Product Change Notification

Change Notification #: 112361 - 00
Change Title: Intel® Server System P4308IP4LHJC and Intel® Workstation System P4304CR2LFKN PCN 112361-00, Product Design Update BIOS/ME/BMC/FRUSDR Firmware and Serial Cable Length
Date of Publication: June 17, 2013

The picture below shows the stand-off pre-installed on the server board:

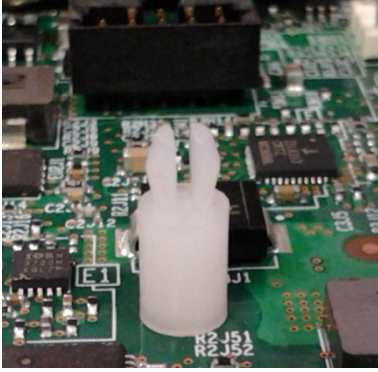
1. The server board Printed Board Assembly (PBA) revision will be updated from G20993-303 to G20993-305 with below changes:
 - a) Update the BIOS from revision 01.02.0005 to 01.06.0001.
 - b) Update the Manageability Engine (ME) firmware from revision 02.01.05.091 to 02.01.05.107.
 - c) Update the Integrated Baseboard Management Controller (BMC) firmware from revision 01.00.2812 to 01.16.4010.
 - d) Update the FRUSDR from 1.03 to 1.09.
2. The serial cable length is changed from 290mm to 390mm.
3. A plastic stand-off will be pre-installed on the server board. Users can install an eUSB SSD device on the stand-off.
